ADDENDUM NO. 4

VALE FACILITY ADDITION/RENOVATIONS AND MAINTENANCE/IT FACILITY PROJECTS

This Addendum consists of pages ADD 4-1 and attached and attached Addendum No. 4 from Gibraltar Design dated September 29, 2025, consisting of 2 pages and 6 Drawings.

Addendum Four (AD.04) to the drawings and specifications prepared by Gibraltar Design for **Valparaiso Vale Facility Addition/Renovations and Maintenance/It Facility and Related Work** for Valparaiso Community Schools, Valparaiso, Indiana.

C-101

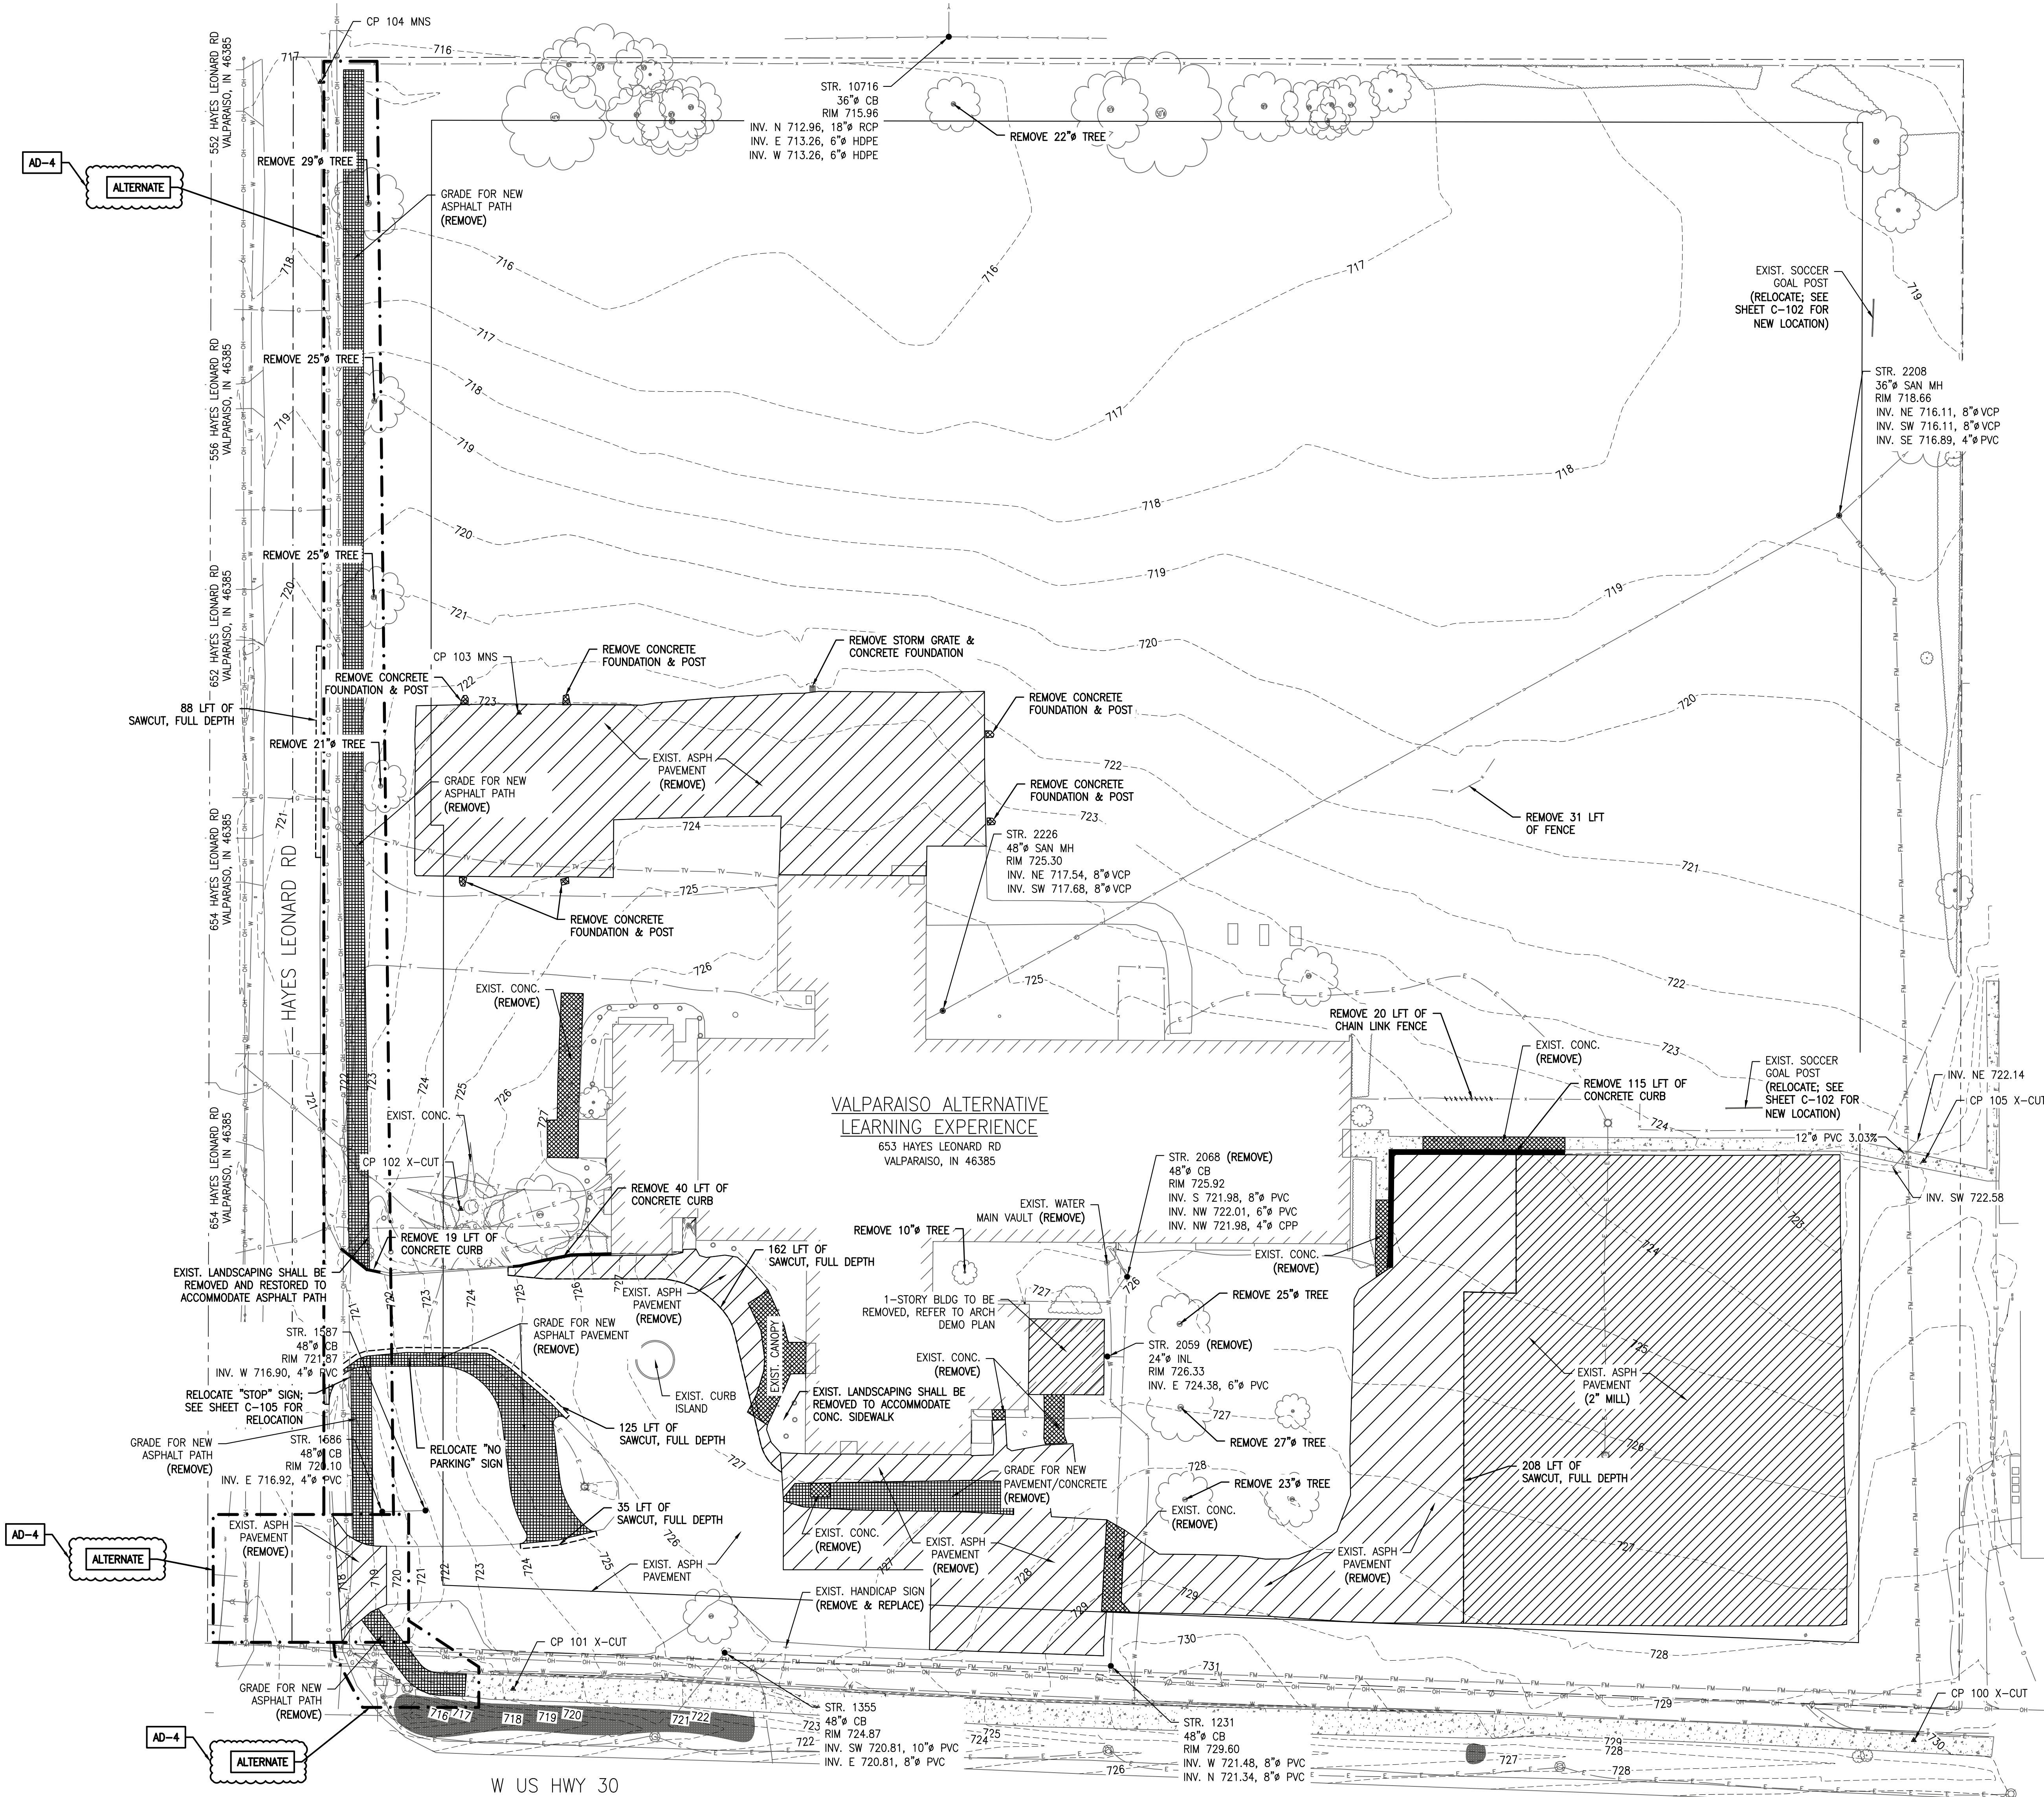
2. Sheet C-101

- A. Refer to revised, full-size drawing, included in this Addendum, for revisions below.
 - 1. Labeled the existing South driveway to be removed as an Alternate.
 - 2. Labeled the areas to be excavated for the proposed multi-use path as an Alternate.

- LABELLED THE EXISTING SOUTH DRIVEWAY TO BE REMOVED AS AN ALTERNATE.
- LABELLED THE AREAS TO BE EXCAVATED FOR THE PROPOSED MULTI-USE PATH AS AN ALTERNATE.

C-103

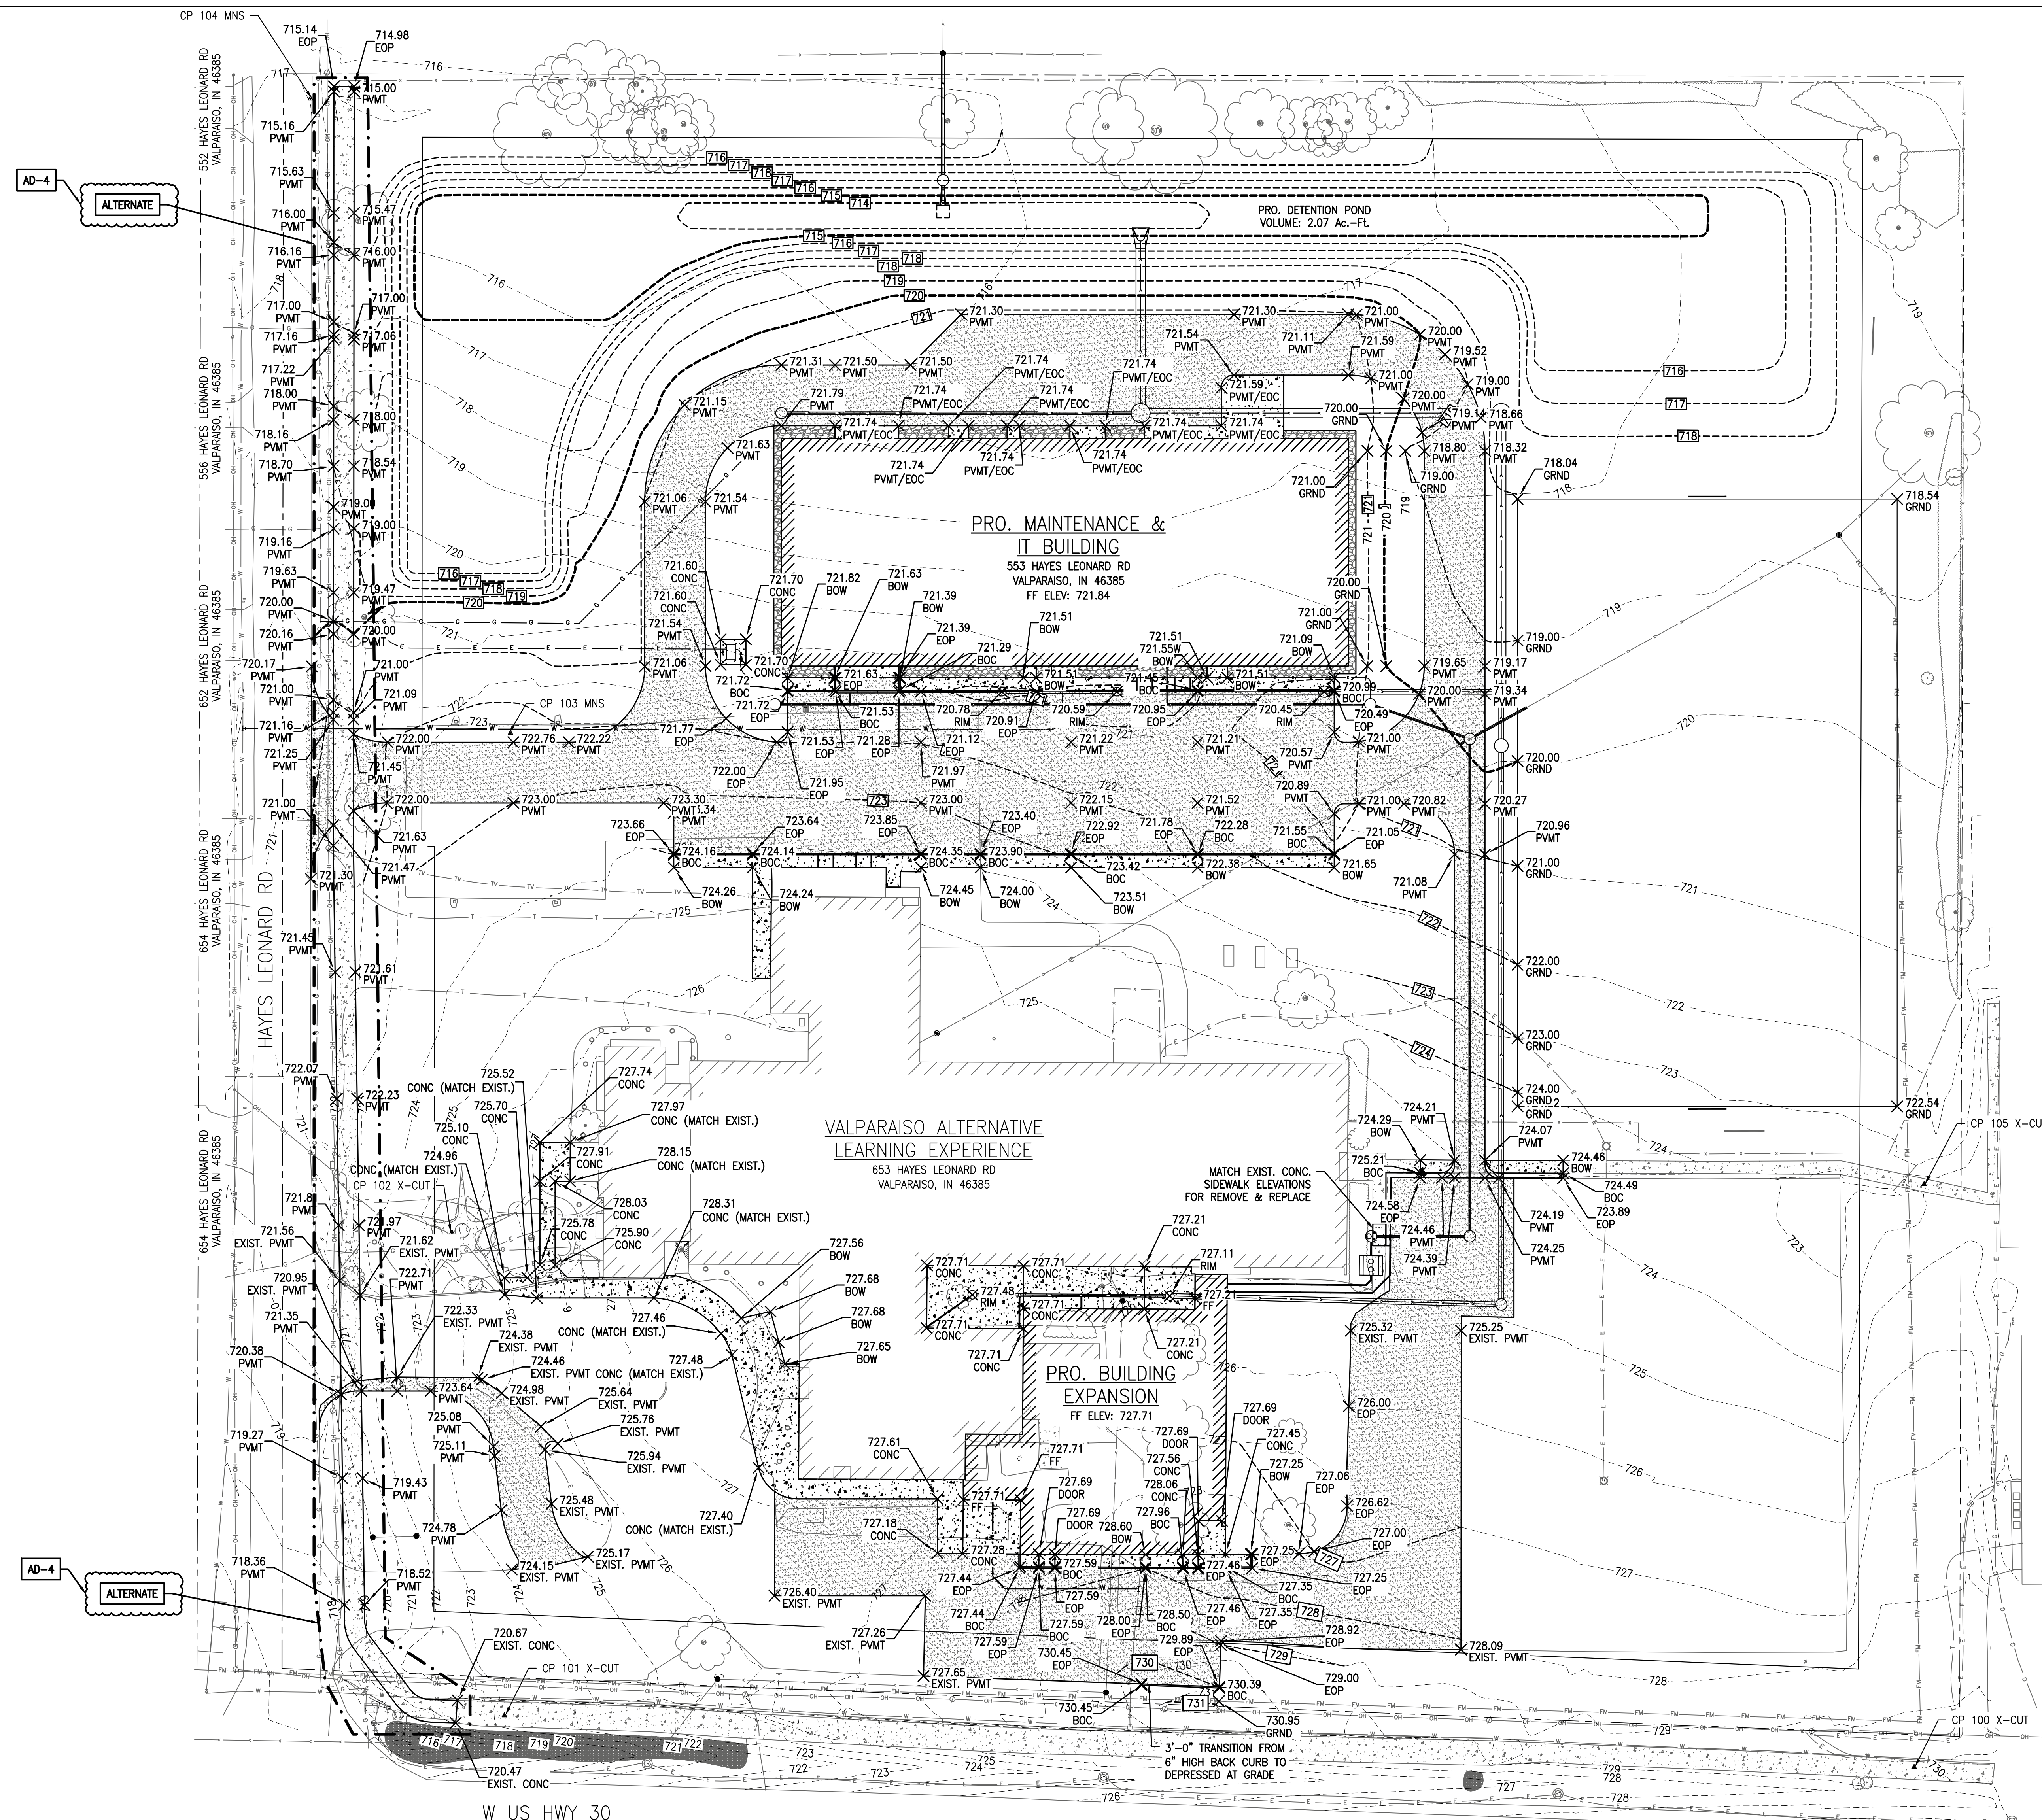
4. Sheet C-103

- A. Refer to revised, full-size drawing, included in this Addendum, for revisions below.
 - 1. Labeled the proposed grading for the multi-use path as an Alternate.

1. LABELED THE PROPOSED GRADING FOR THE MULTI-USE PATH AS AN ALTERNATE.

C-105

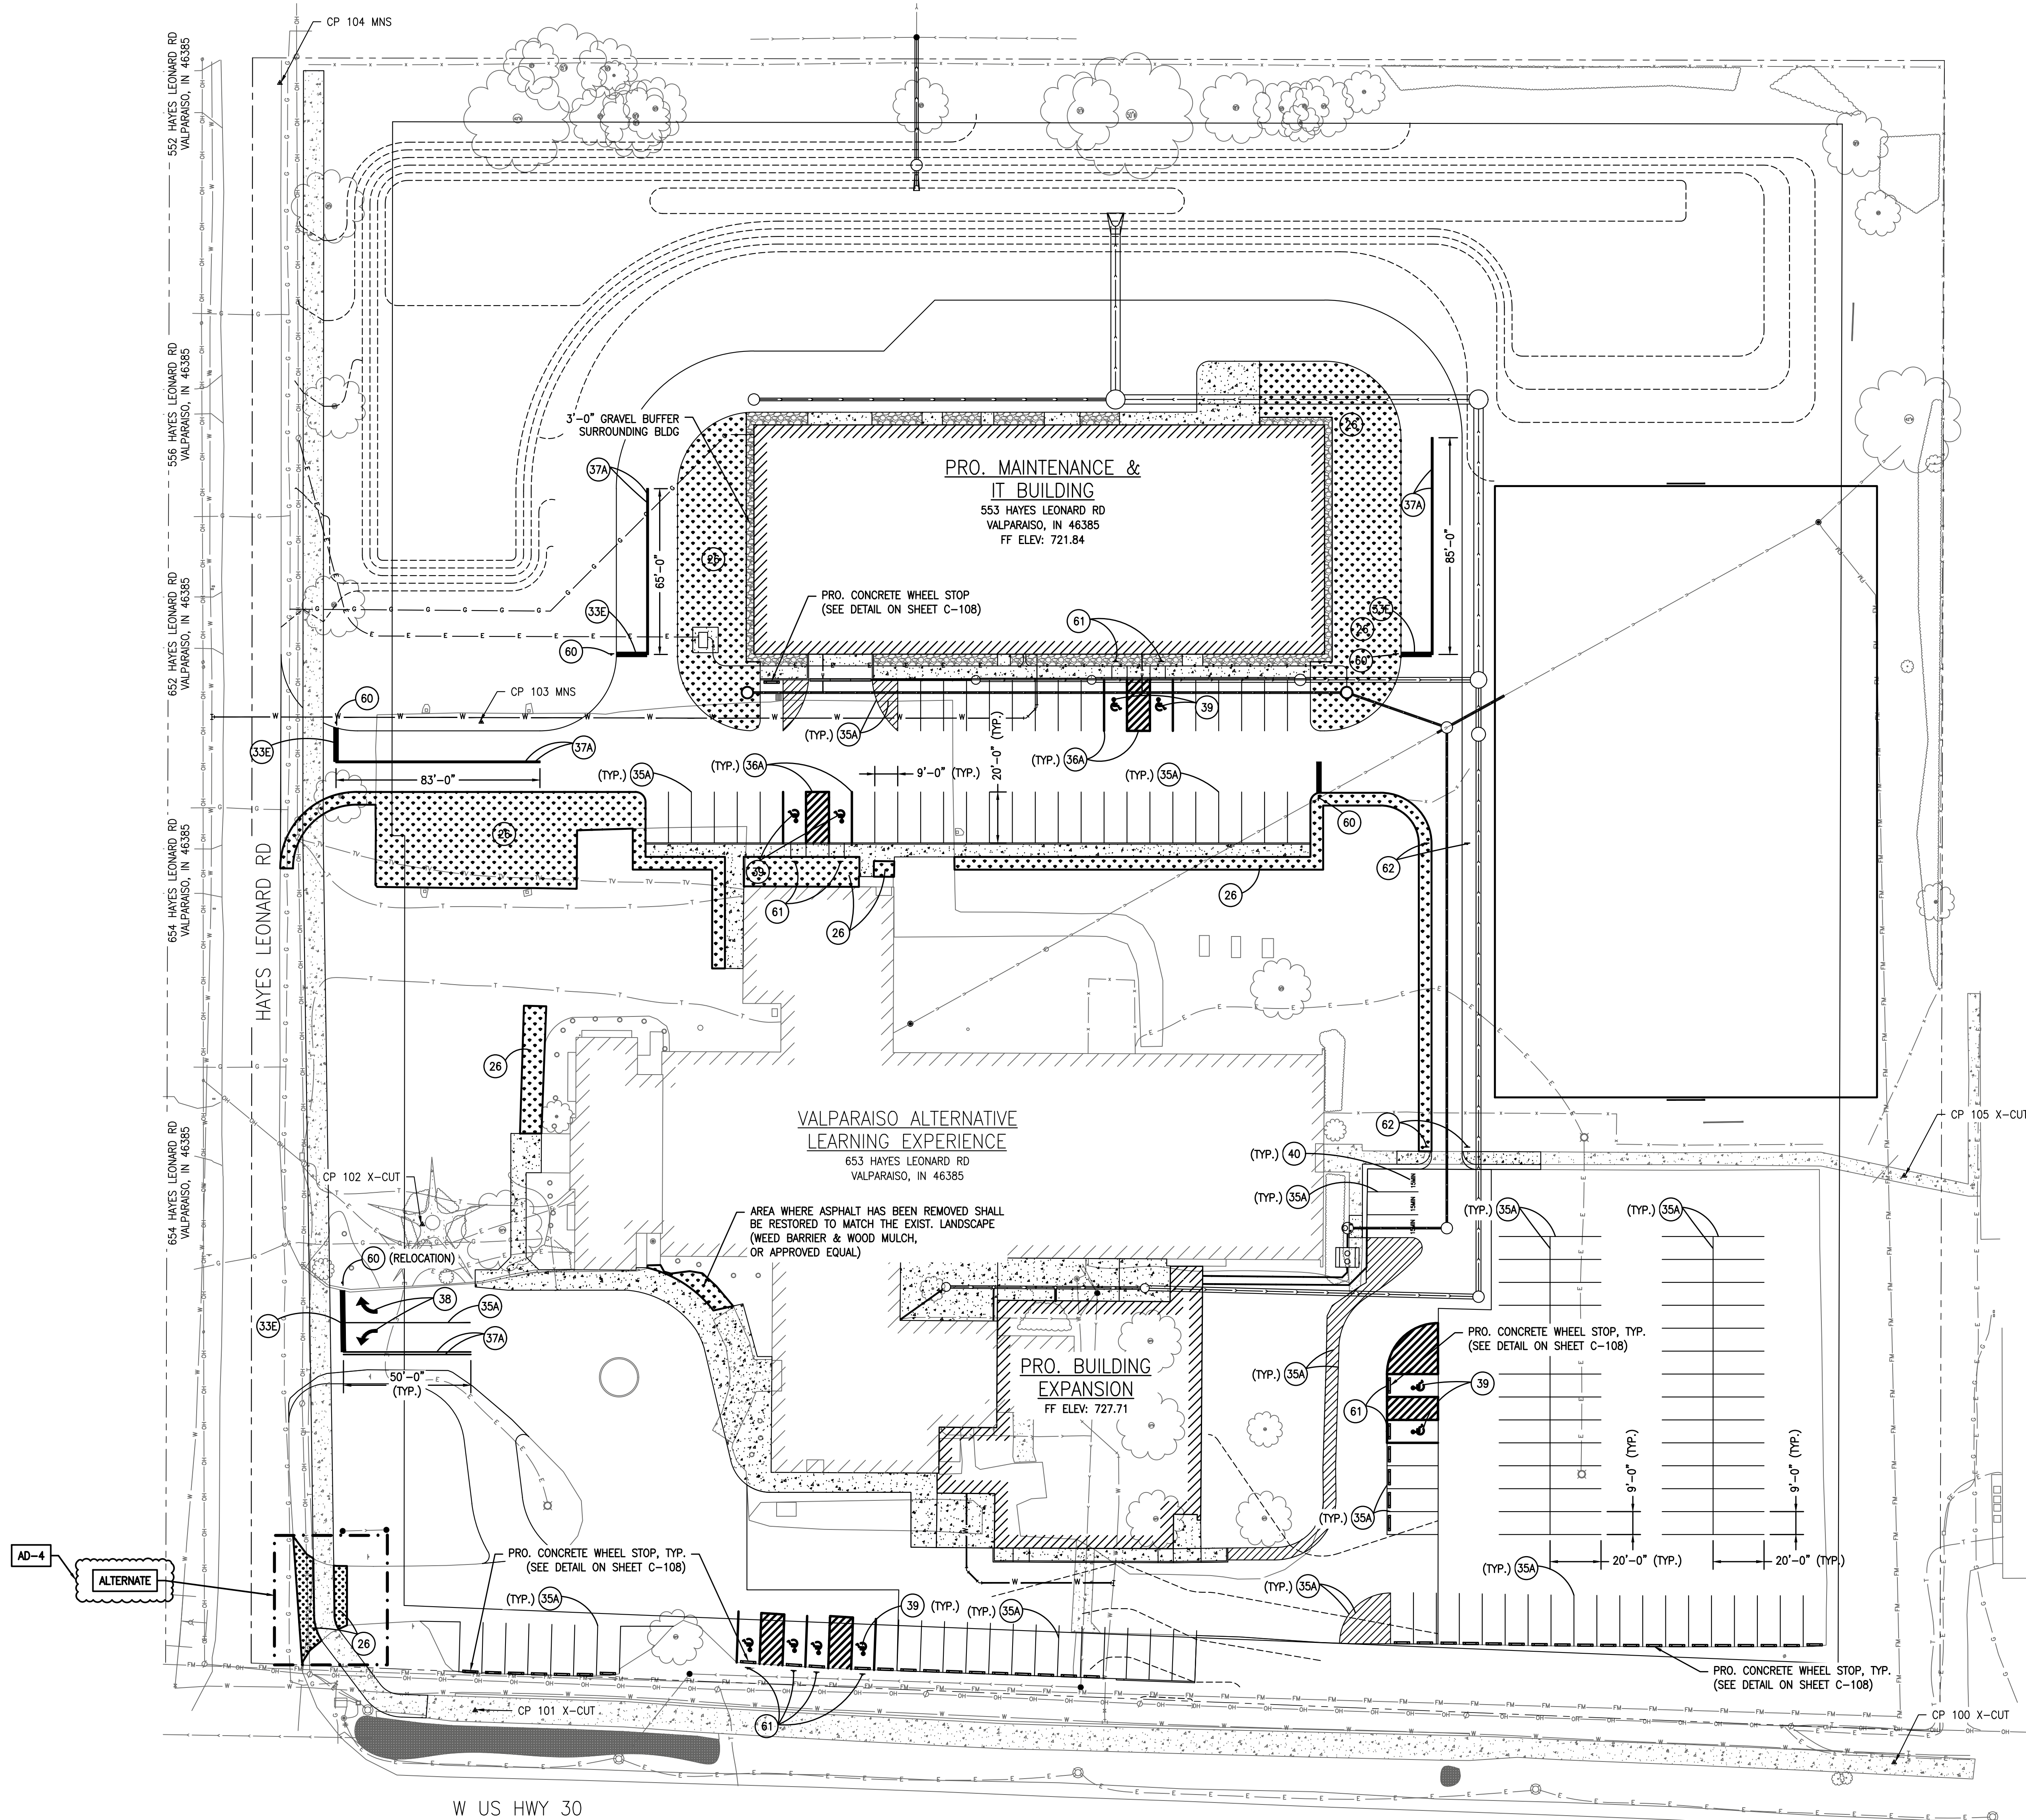
5. Sheet C-105

- A. Refer to revised, full-size drawing, included in this Addendum, for revisions below.
 - 1. Labeled the restoration of the removed South driveway as an Alternate.
